ADDENDUM

ADDENDUM NO.: 04
PROJECT NAME: Salt Dome Replacement Facility (Grand Avenue)
PROJECT NO.: 04021
CONTRACT NO.: C1598
DATE OF ISSUE: January 27, 2021

NOTICE OF CHANGES, MODIFICATIONS, OR CLARIFICATIONS TO CONTRACT DOCUMENTS

Sheet
AS1.1

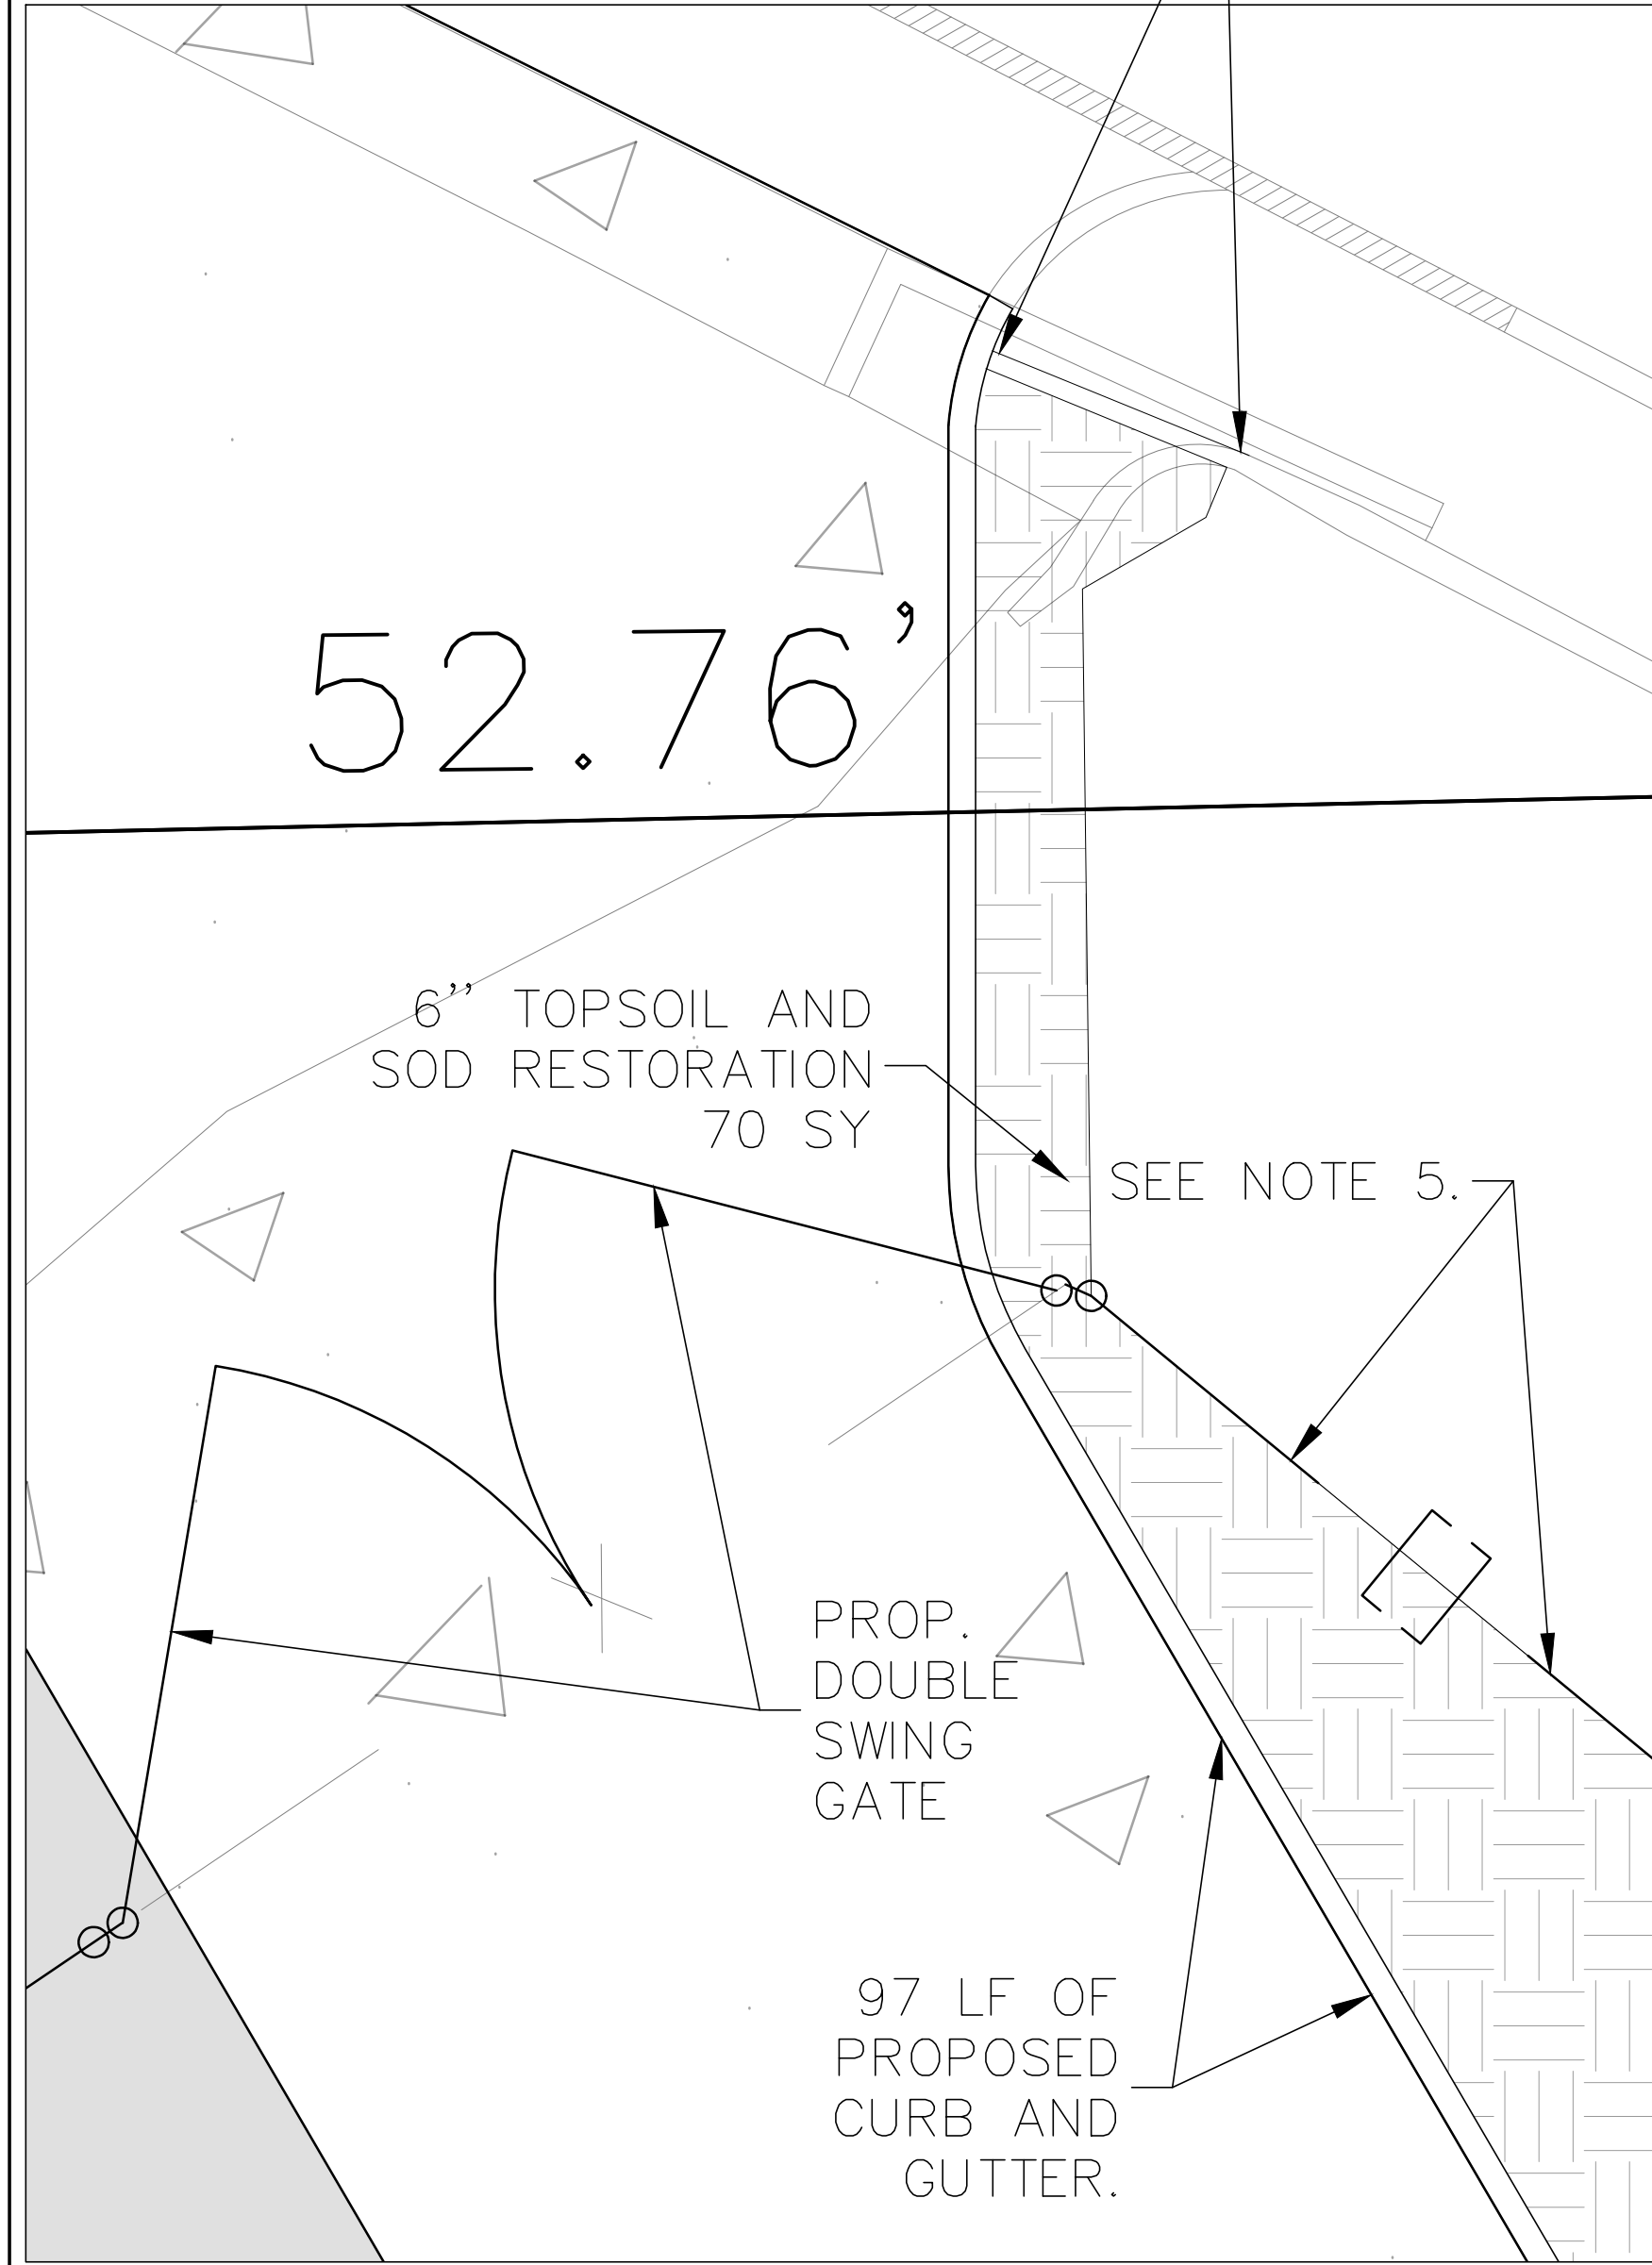
Change 1 **REVISED** Drawing No. AS1.1, Site Plan: Keynote N014 revised to clarify surface material. Surface material adjacent to dome revised to match civil drawings.

Question: The Architectural site plans indicate that the surface outside of paved areas is to be covered in asphalt millings. C1.2 indicates that the surface outside of pavement is to be 6” of CA-6. Which is correct?

Question: Drawing sheet C1.2, shows a ring of 6" CA-6 aggregate between the dome and the concrete pavement. Sheet C1.2A shows this same ring as reclaimed asphalt millings. Sheet A1.1 shows this same ring as replaced gravel millings. Sheet AS1.1 shows this same ring to be top soil and seeding. Please clarify what is to be placed between the dome and the concrete pavement around the dome.

Response: Revised Drawing sheet C1.2, C1.2A and AS1.1, have been revised and included in this Addendum. The Contractor should assume that the typical surface outside of paved areas is a minimum of 6" of CA-6. Where existing asphalt milling surface exceeds 3" and is undisturbed it may be left in place.

Response: Drawing Sheet C1.2, C1.2A, and AS1.1 have been revised to show the scope of Work. The proposed surface between the dome and the ring road shall be a 6" minimum thickness layer of CA-6.

OVERALL SITE PLAN

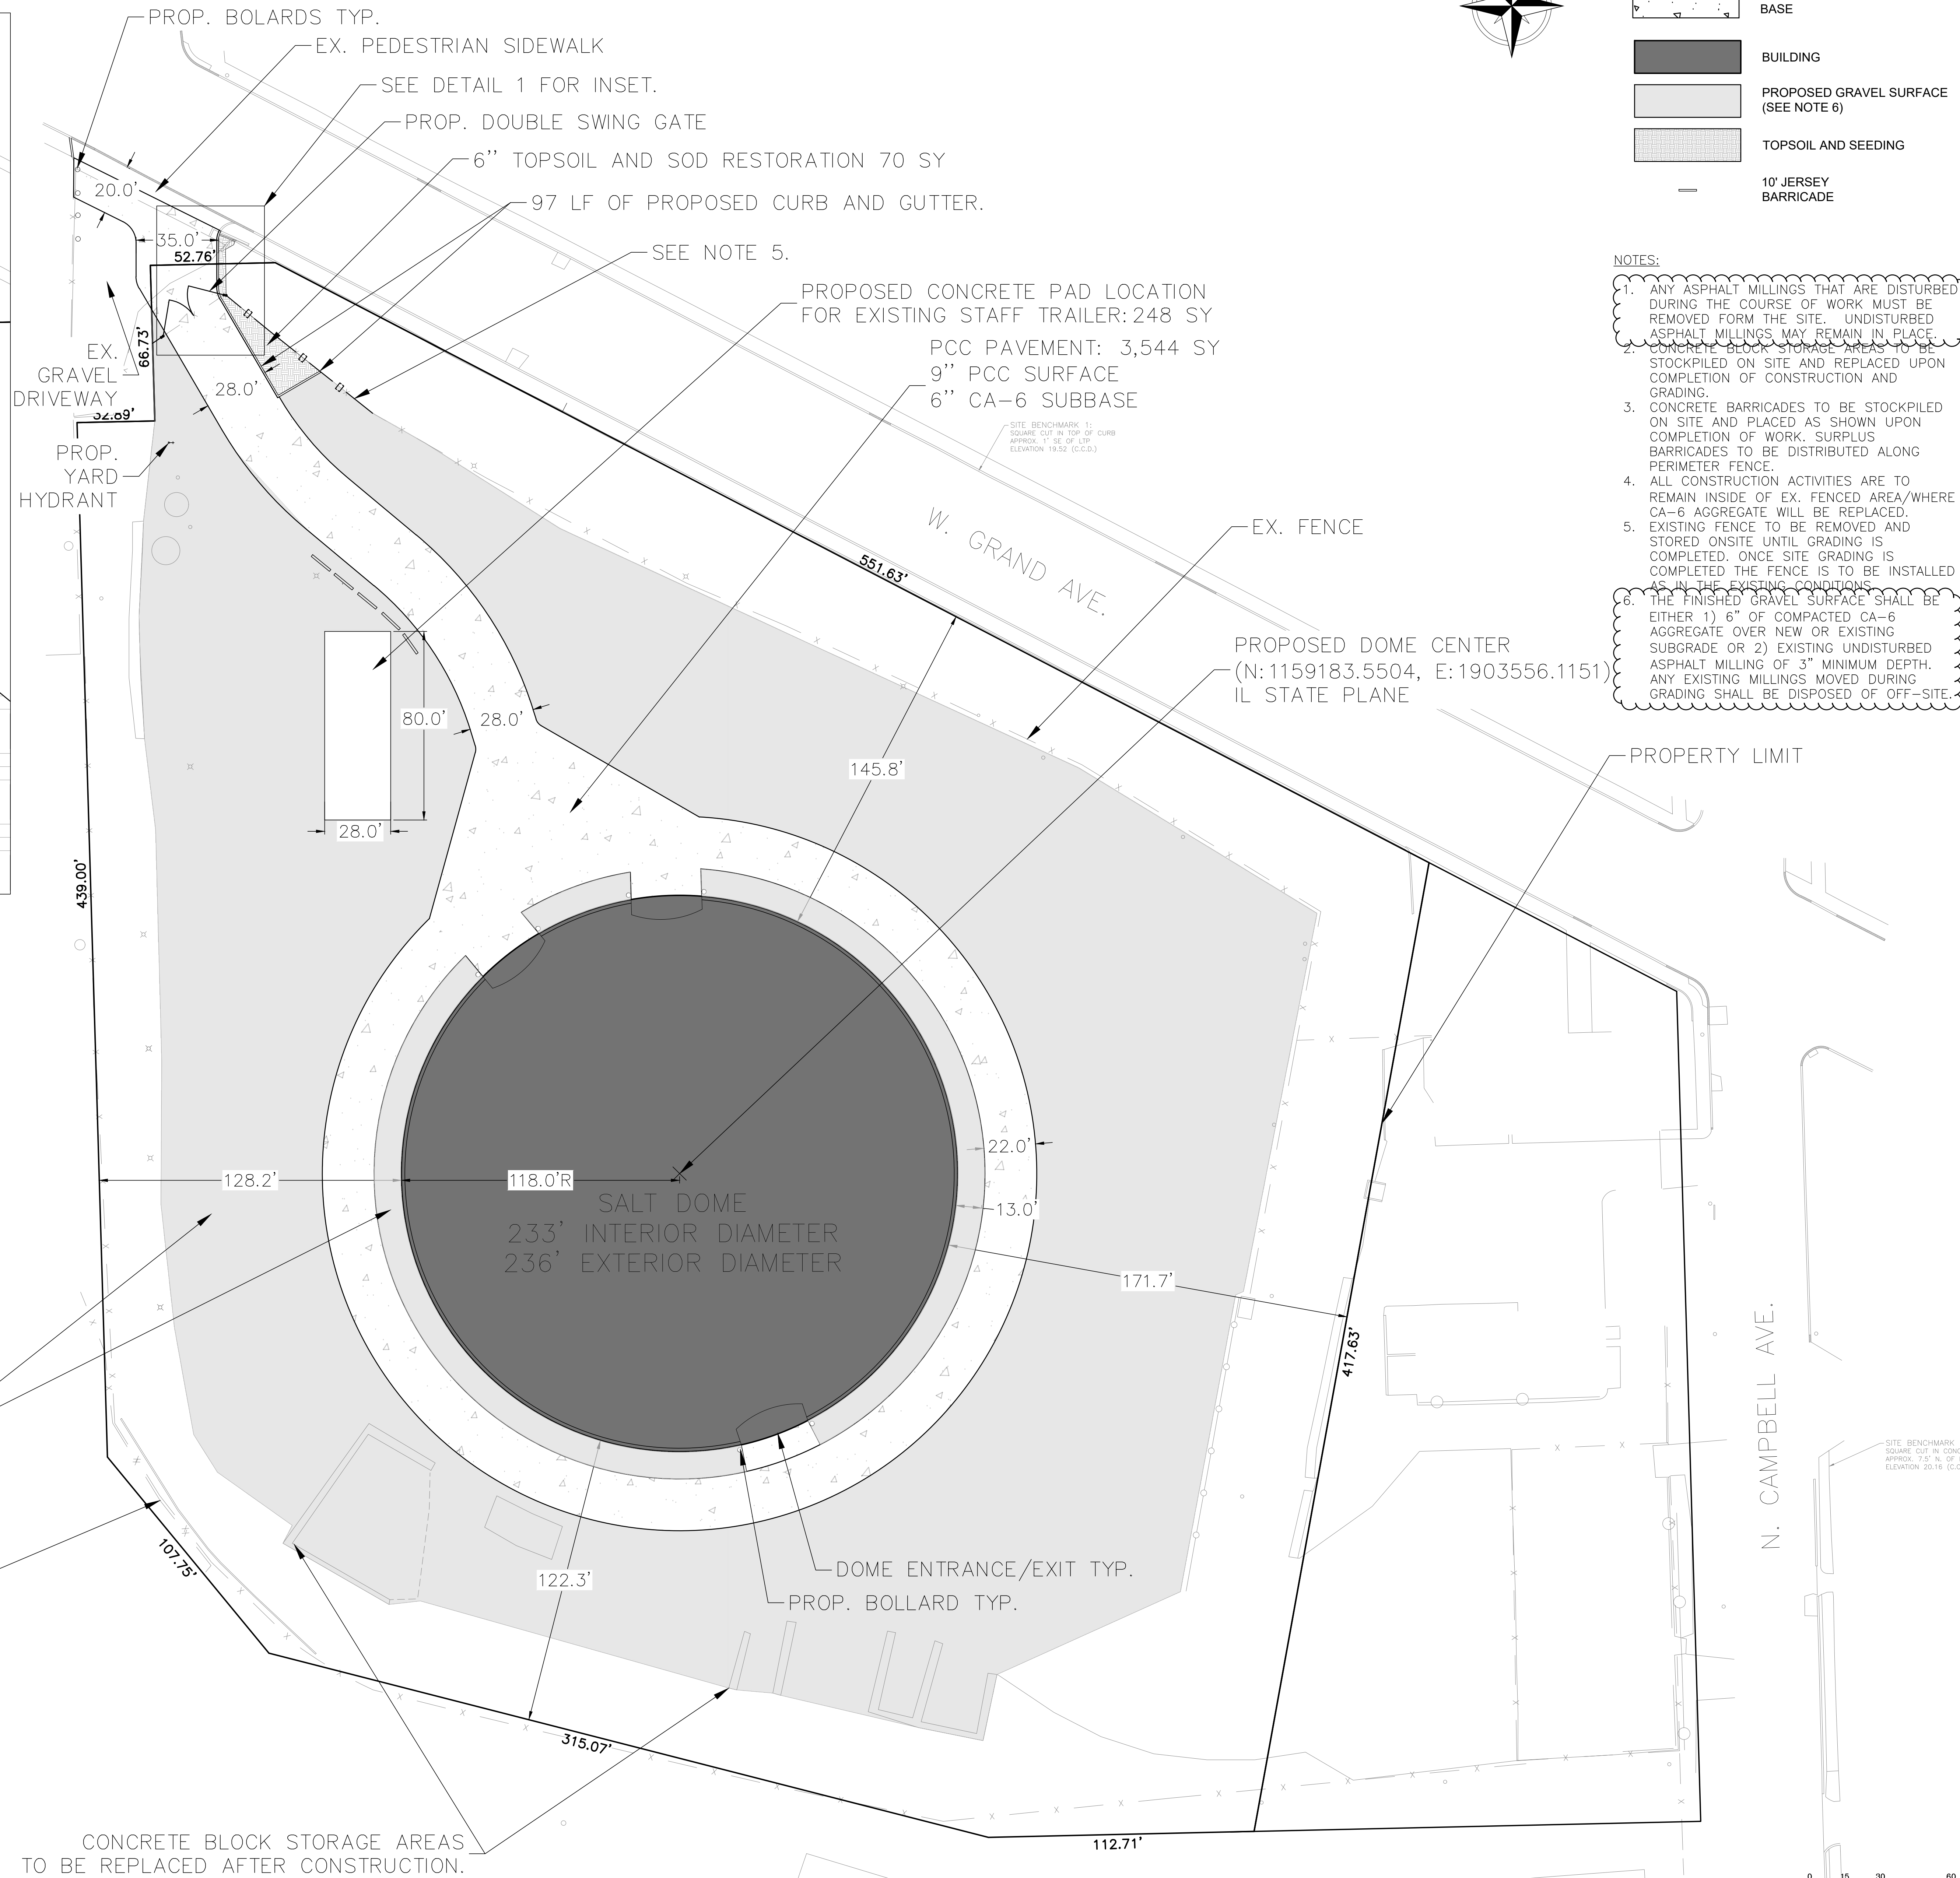
Change 2 **REVISED** Drawing No. C1.2, Overall Site Plan: Updated note 1 to clarify scope of work related to asphalt millings. Added note 6 and updated legend and callouts to clarify scope of proposed gravel surface.

Question: C1.2 and C1.2A notes one states that “The existing asphalt millings shall be taken hauled offsite due to environmental concerns.” Please confirm the depth of removal required.

Question: Drawing sheet C1.2, note #1 indicates "The existing asphalt millings shall be taken hauled offsite due to environmental concerns". Sheet SM-1, note 10 indicates "Existing asphalt grindings are allowed to remain in place on the surface of the site if they are undisturbed". Please clarify if all asphalt grindings within the work area are to be taken off site or only asphalt grindings disturbed.

Response: Drawing Sheet C1.2 has been revised and included in this Addendum to be consistent with SM-1. All excavated or disturbed asphalt grindings are to be properly disposed to a Subtitle D facility. The Contractor should not reuse excavation spoils for fill.
